## ADDENDUM NO. 1

PROJECT NAME: **Huebner Creek Greenway Hike and Bike Trail Extension – BID #2026-01  
(CSJ 0915-12-735)**

DATE: **January 27, 2026**

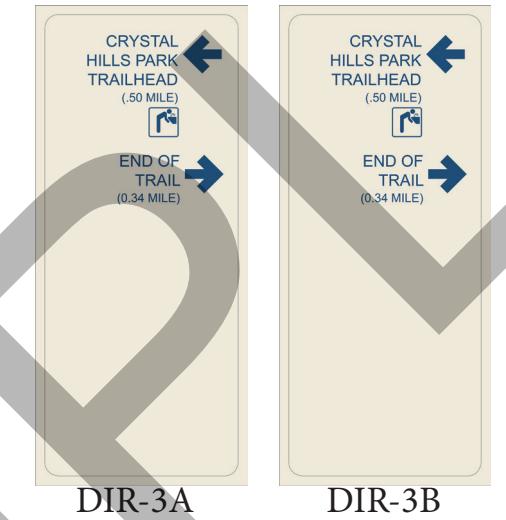
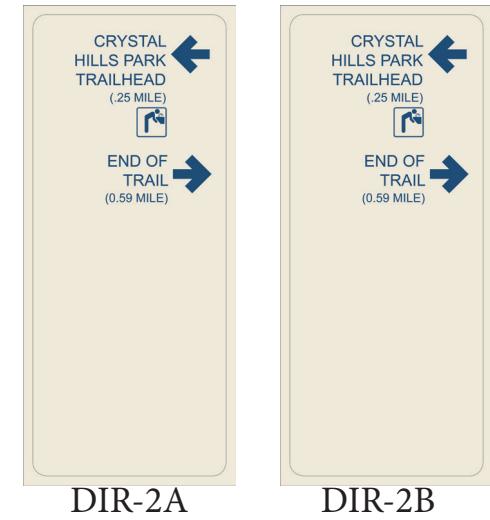
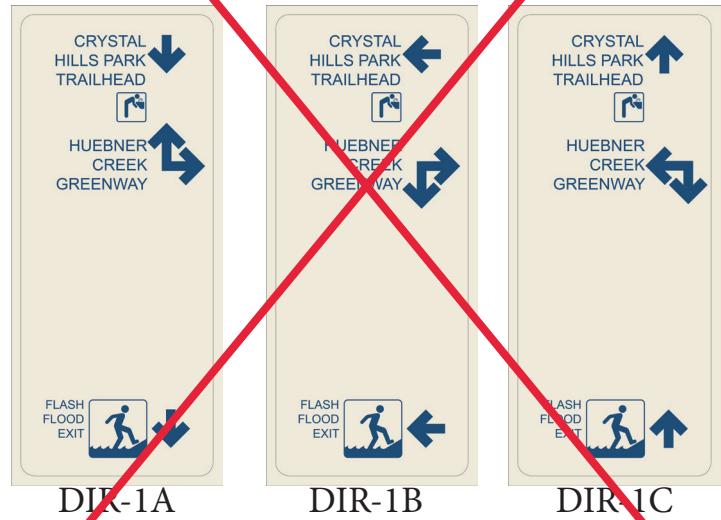
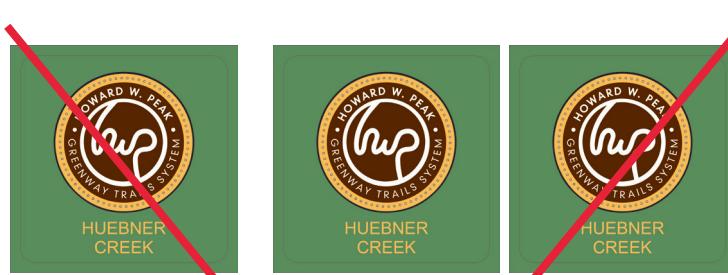
7. Add Pages 206A-206G to the Contract Document to include TxDOT Item 247-Flexible Base specification for the temporary sidewalk.
8. Add Page 277A to the Contract Document to include the example design for the Trailhead Sign (SS1003-COLV)

9. Add Page 278A to the Contract Document to include the example design for the Direction Monument (SS1004-COLV)
10. Remove and replace Page 2 of the Plan Set to add TCP (2-4)-18 standard to the Sheet Index.

TRAFFIC CONTROL PLAN  
SEQUENCE OF WORK

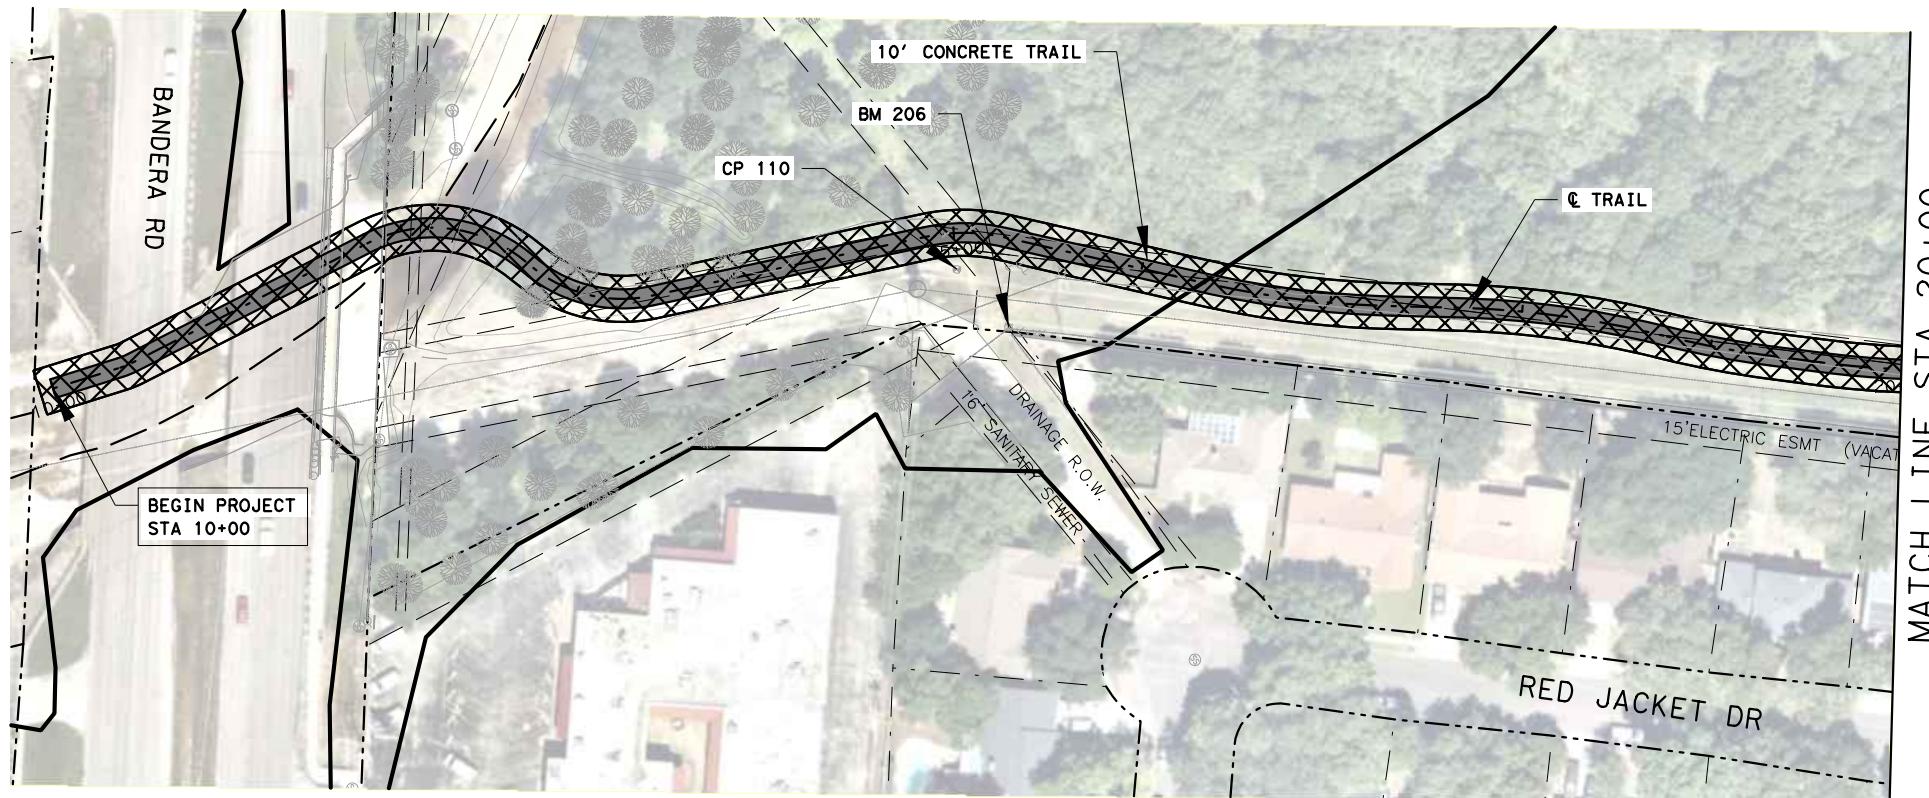
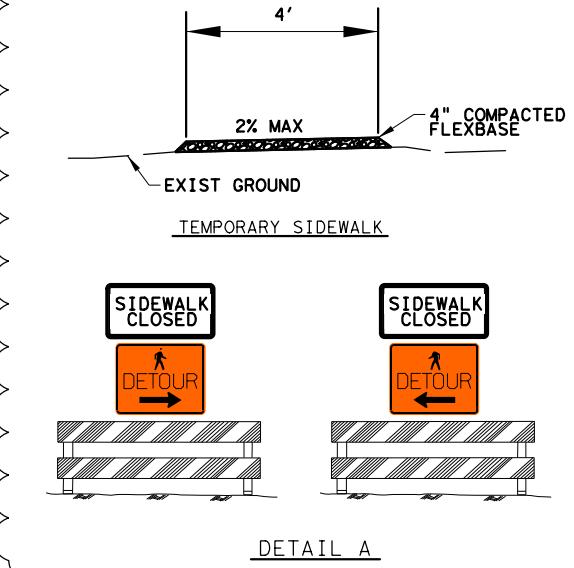
11. Remove and replace Page 14 of the Plan Set to include Item 247-Flexible Base to the Summary Sheet.
12. Remove and replace Page 16 of the Plan Set to edit notes to remove sodding references and include application of TCP on Evers Rd.

FED. RD. DIV. NO.	FEDERAL AID PROJECT	SHEET NO.
6	2B25 (182)	19
STATE	DIST.	COUNTY
TEXAS	SAT	BEXAR
CONT.	SECT.	JOB
0915	12	SH16

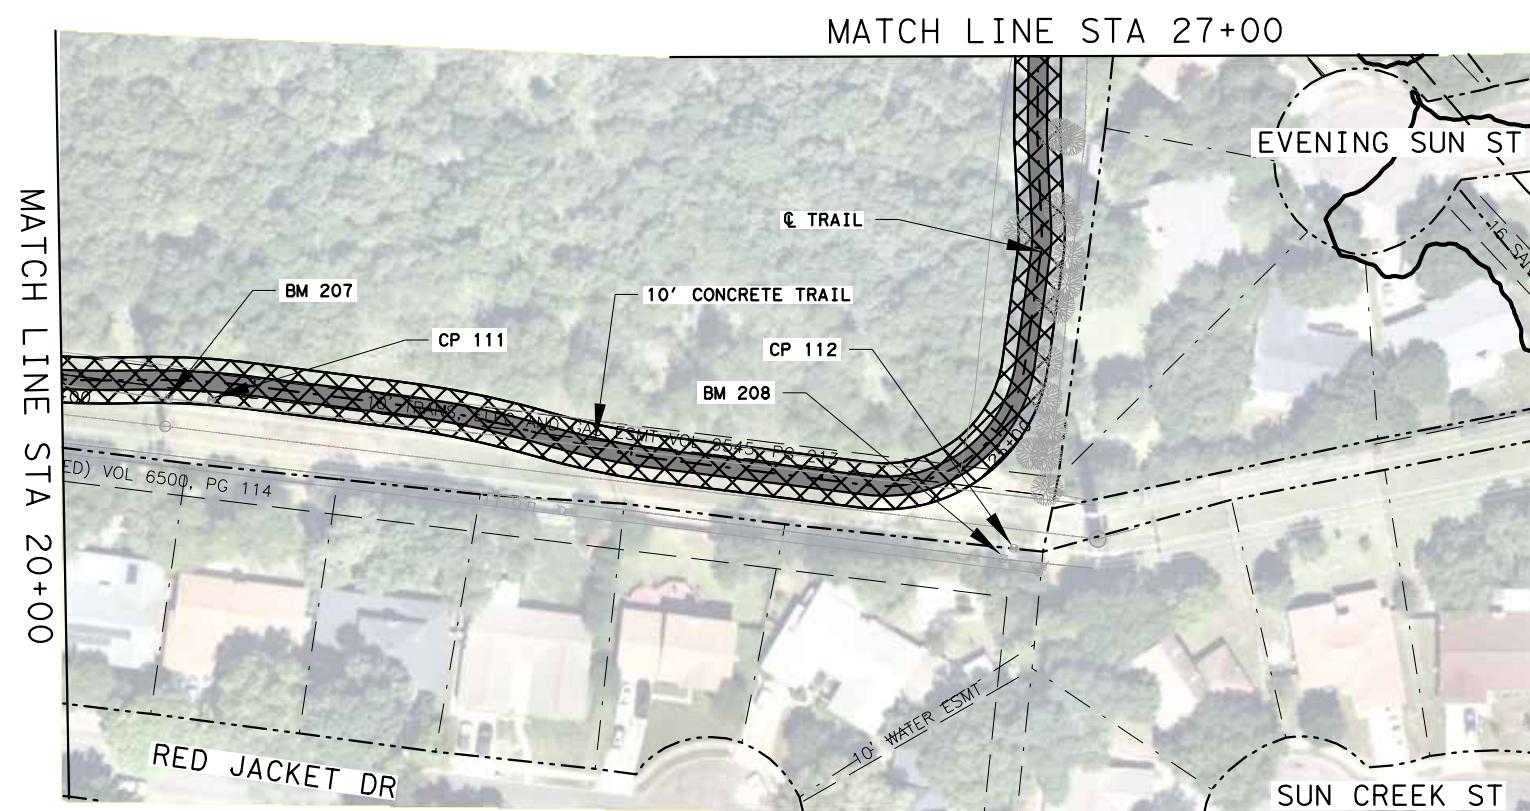
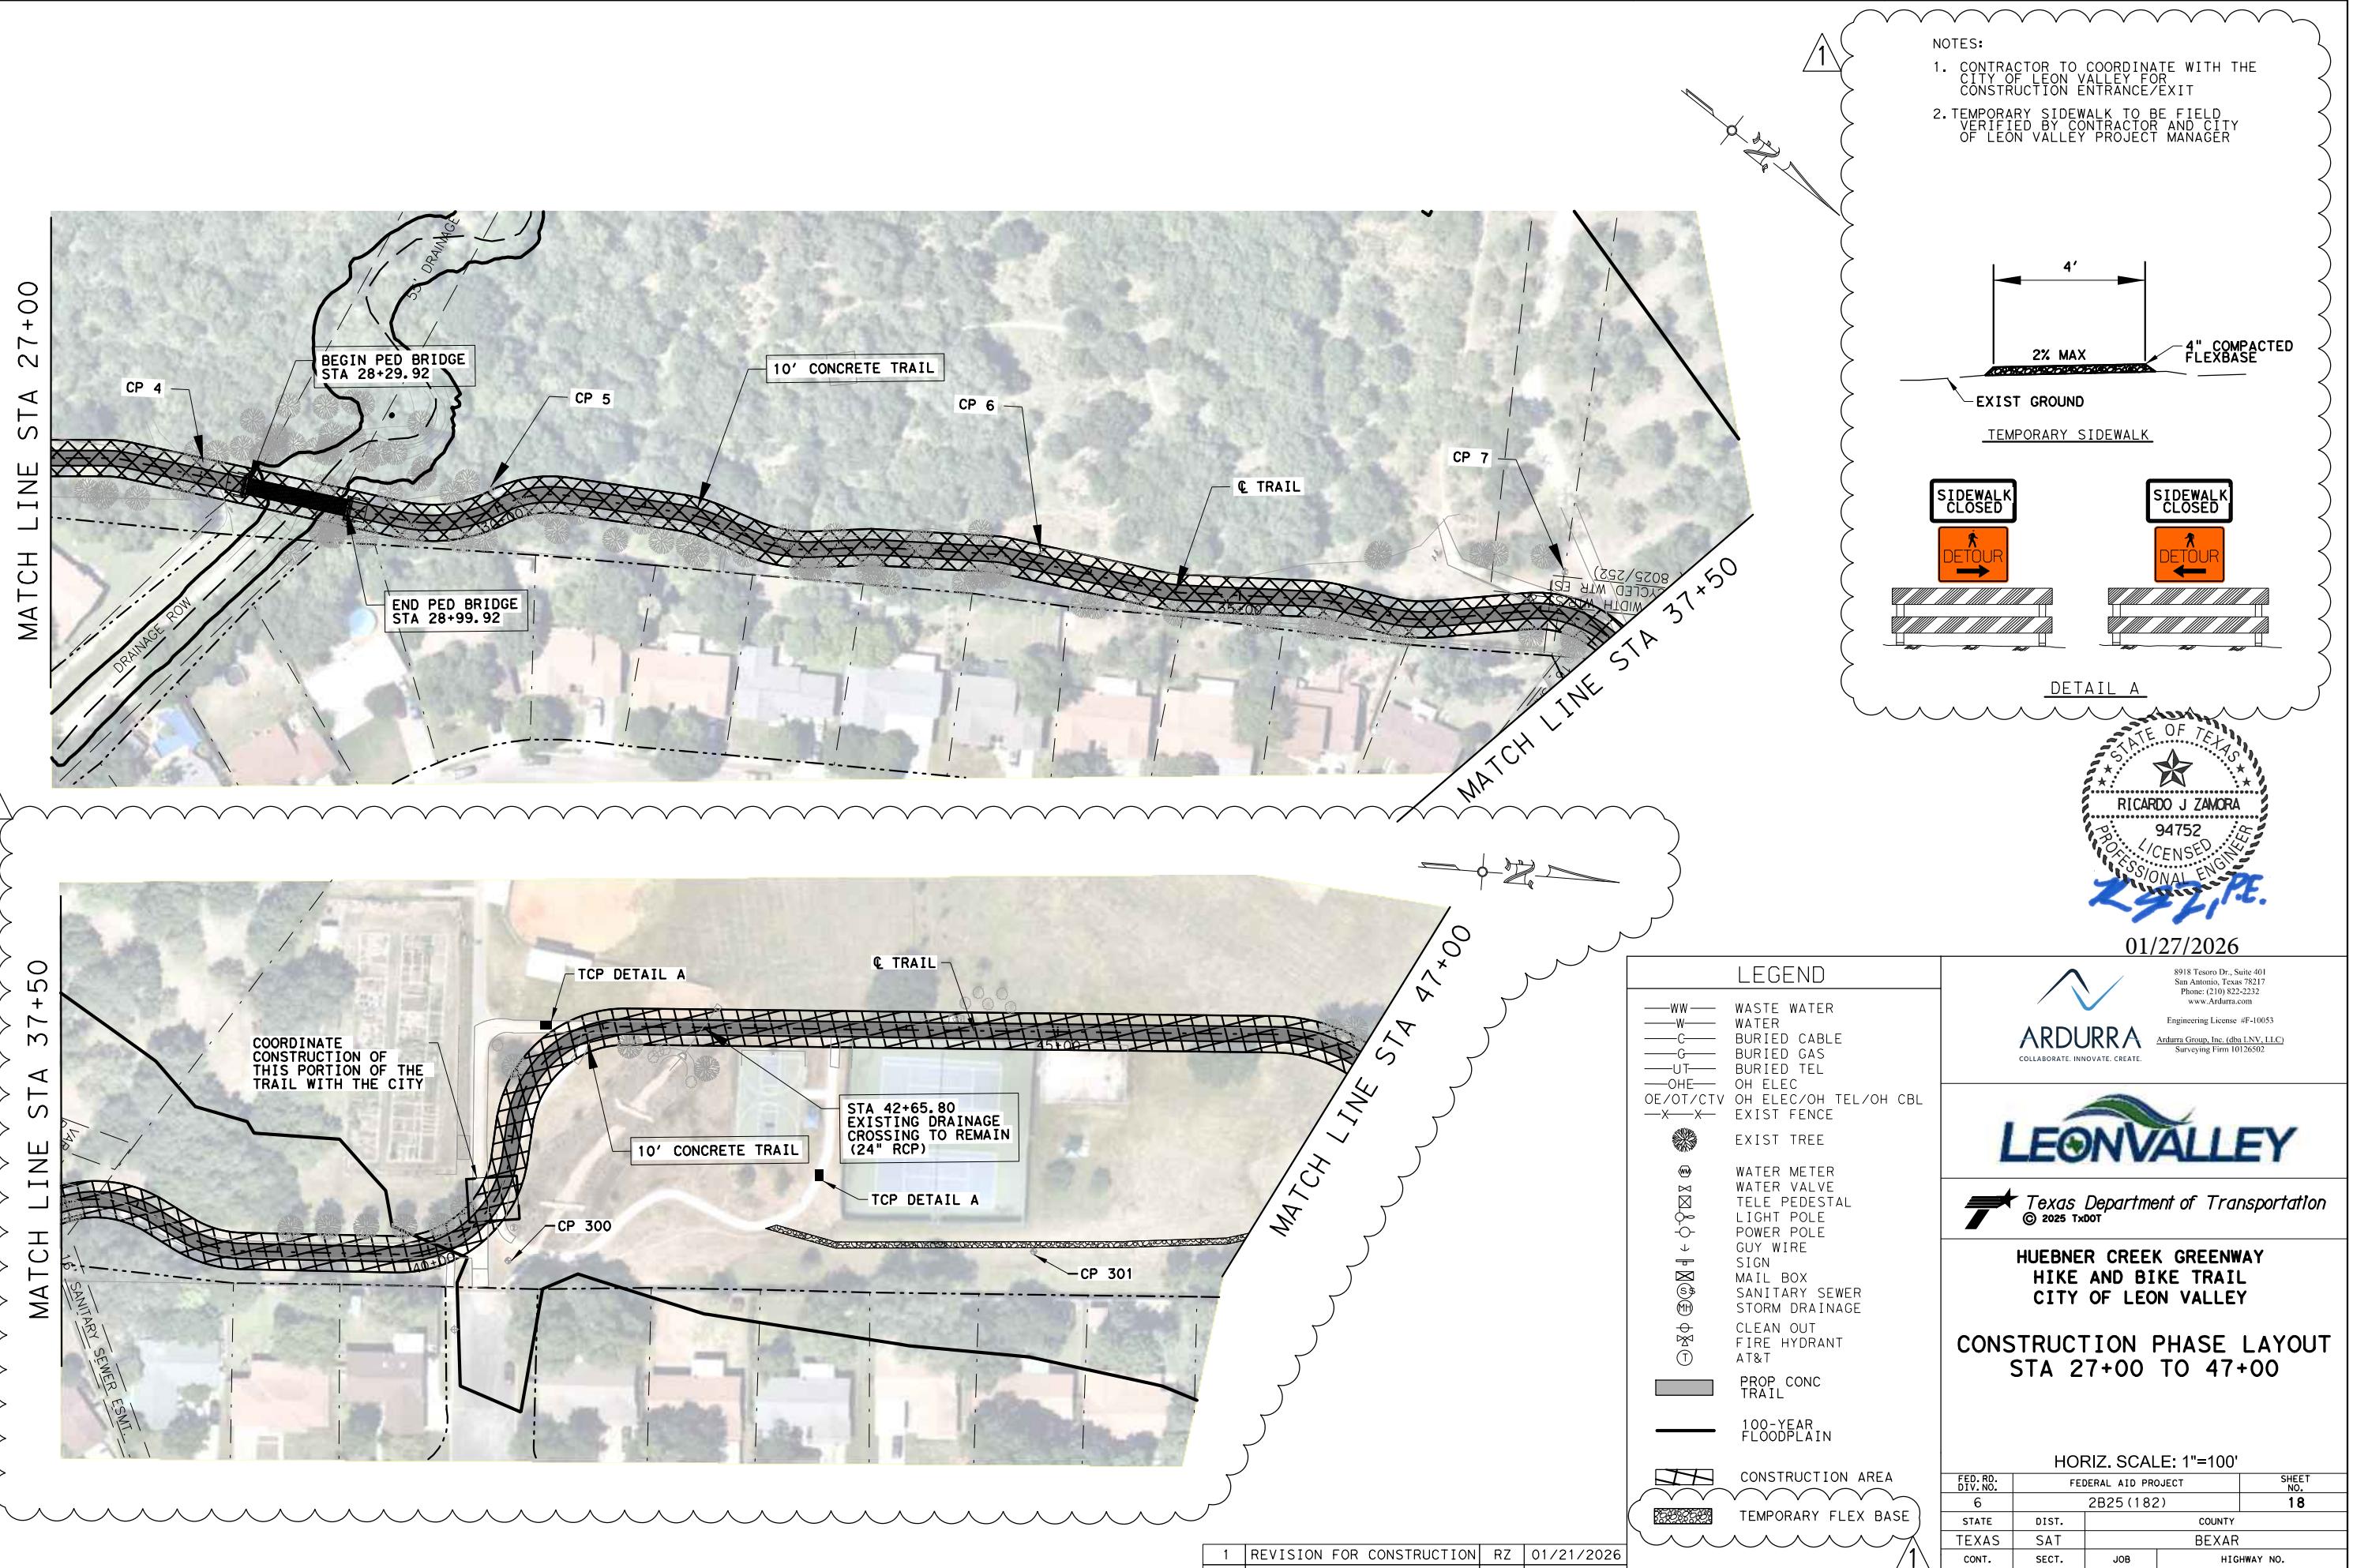
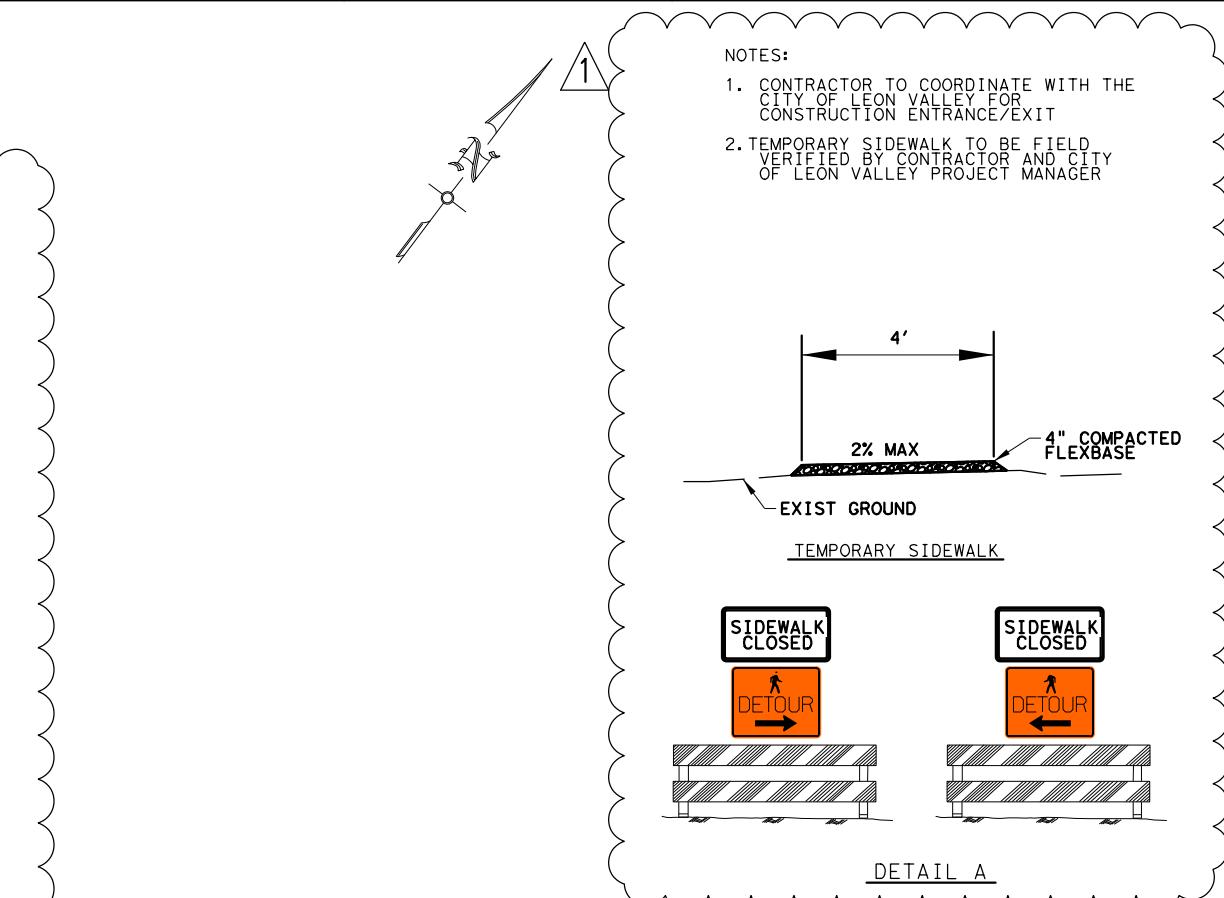
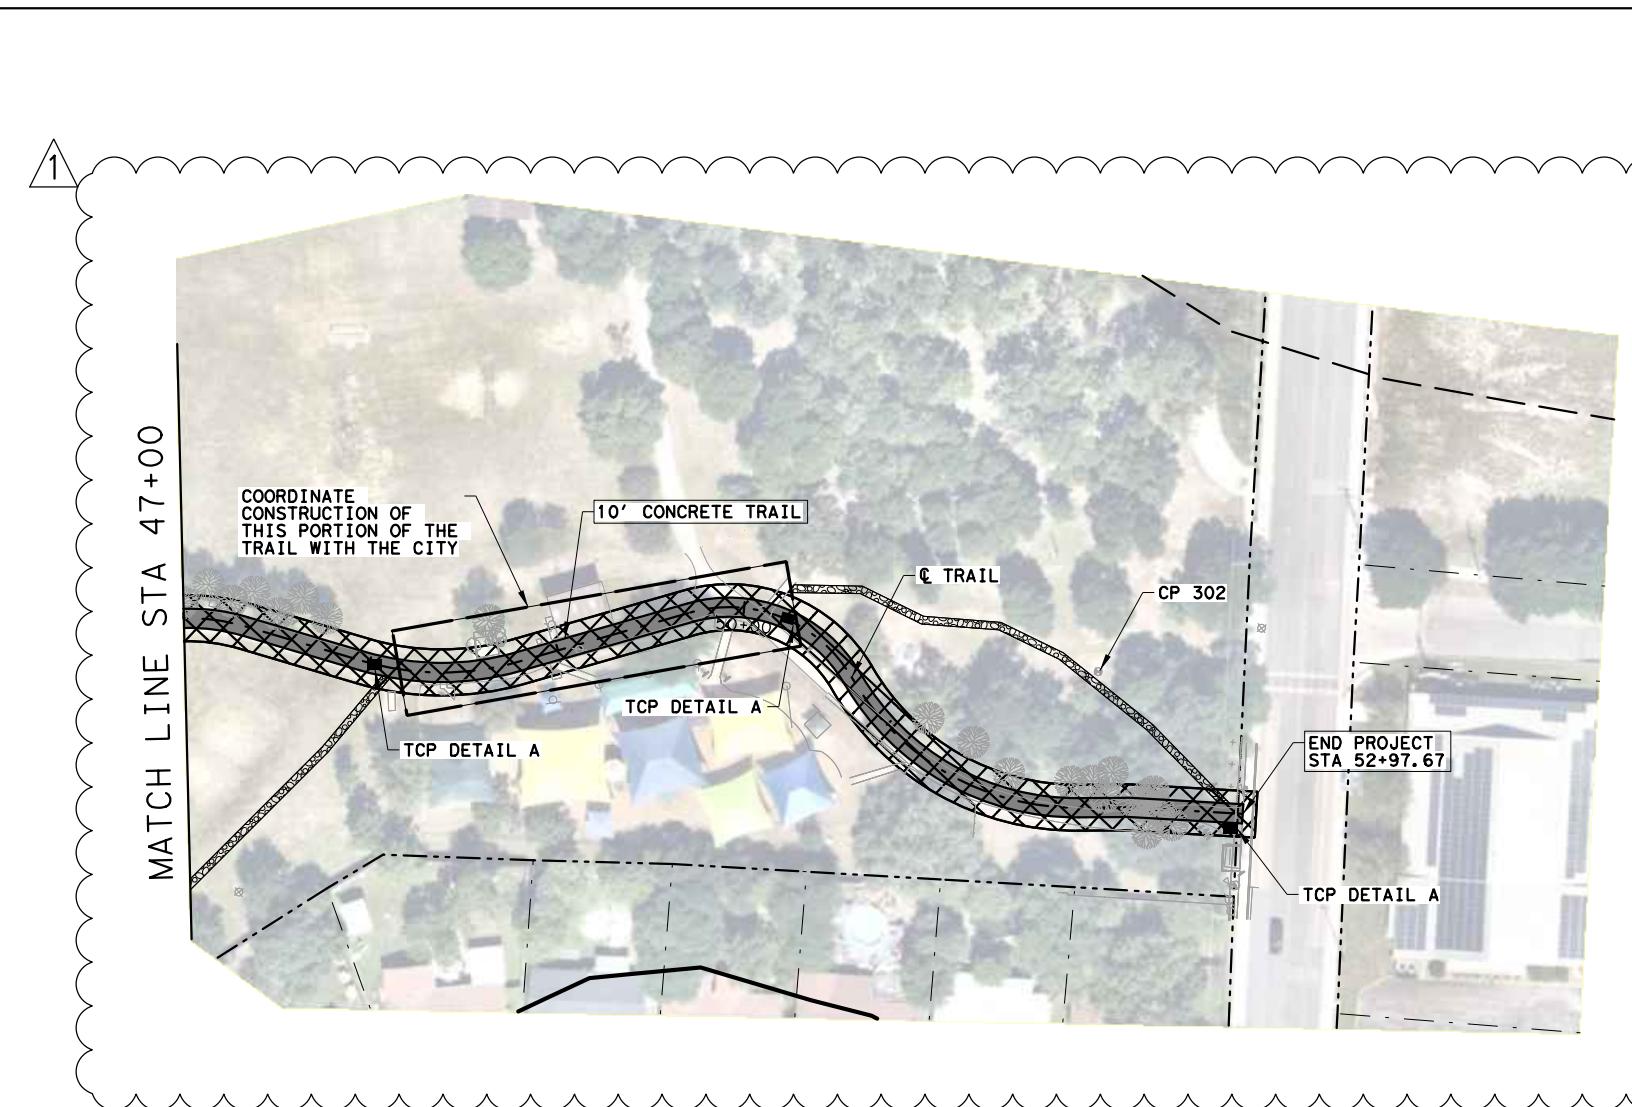
6. Limits and location of the temporary sidewalk have been added to the plans.
7. Concrete riprap detail was added to the plans.
8. The City of Leon Valley construction permit fees will be waived for this project.

13. Remove and Replace Pages 17, 18, and 19 of the Plan Set to add location of temporary sidewalk.
14. Add Page 31a to the Plan Set to include TxDOT Standard TCP(2-4)-18.
